# Access Compliance Report

## Public Rights-of-Way

### (Curb Ramps)

Intersection ID: 14435	Main Street: WEST_BV	Cross Street: DAWNALIA_DR	Location: SE
ADA ID: 3364FB9FD6EC	Ramp Type: Directional1	Initial Pass/Fail: Fail	Overall Compliance: No
Severity Score: 1.25			
Codes/Mitigation Info/Possible Solution		Field Measurements/Component Compliance

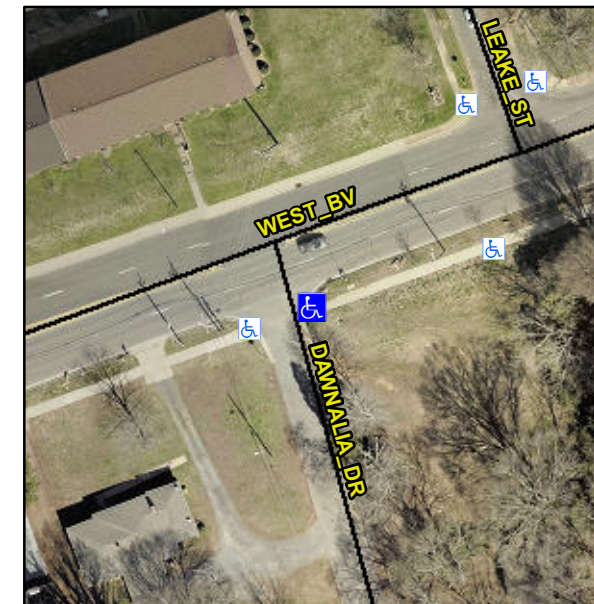
**R304.5.3**

Compliance	Description	Data	Compliance	Description	Data
N/A	Ramp Length (in)	109.0	N/A	Grade Break?	N/A
Yes	Ramp Width (in)	71.0	N/A	Grade Break Slope (%)	0.0
Yes	Ramp Slope (%)	5.0	N/A	Grade Break XSlope (%)	0.0
No	Ramp XSlope (%)	2.7			
N/A	Flare Type LT	N/A	N/A	Flare Type RT	N/A
N/A	Flare Slope LT (%)	N/A	N/A	Flare Slope RT (%)	0.0
N/A	Flare Traversable LT?	N/A	N/A	Flare Traversable RT?	N/A
N/A	Landing Length (in)	0.0	N/A	DWS Provided?	N/A
N/A	Landing Width (in)	0.0	N/A	DWS Contrast?	N/A
N/A	Landing Slope (%)	0.0	N/A	DWS Length (in)	N/A
N/A	Landing X Slope (%)	0.0	N/A	DWS Full Width?	N/A
N/A	Landing Curb? (Y/N)	N/A	N/A	DWS Offset LT (in)	N/A
N/A	Shared Landing?	N/A	N/A	DWS Offset RT (in)	N/A
N/A	Gutter Ponding?	0.0	N/A	Gutter Slope (%)	N/A
N/A	Gutter Lip Ht (in)	0.0	N/A	Gutter X Slope (%)	N/A
N/A	Painted X Walk1?	No		Road Slope (%)	3.0
	X Walk 1 Direction	To SW		Road X Slope (%)	1.1
	X Walk 1 Width (in)	N/A		Clear Space?	N/A

**Remove & Replace Entire Ramp.**
